# ADDENDUM

Project: Shawnee HVAC Replacement

Addendum No.: 1

**A** **CONDENSATE DRAIN DETAIL**  
 NO SCALE

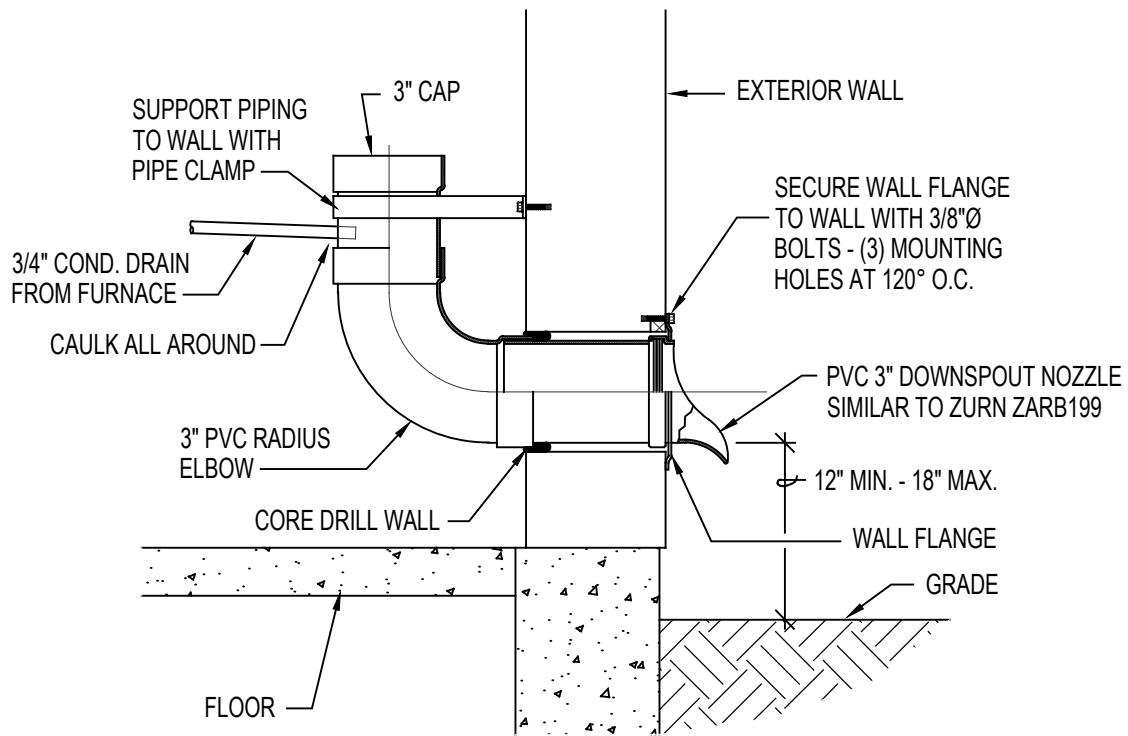
- a. Sheet ME-1: Condensing Units 1, 2, 5 & 6 have been field verified to not exist. This is just for reference, no work to be done with these units.
- b. Sheet ME-1: Mechanical rooms 107, 131, 143, & 161 do not have existing floor drains. Existing cooling condensate is piped through the wall. Install new scupper in exterior wall for furnace condensate. See attached detail A. Run PVC condensate from combustion to new scupper furnace.
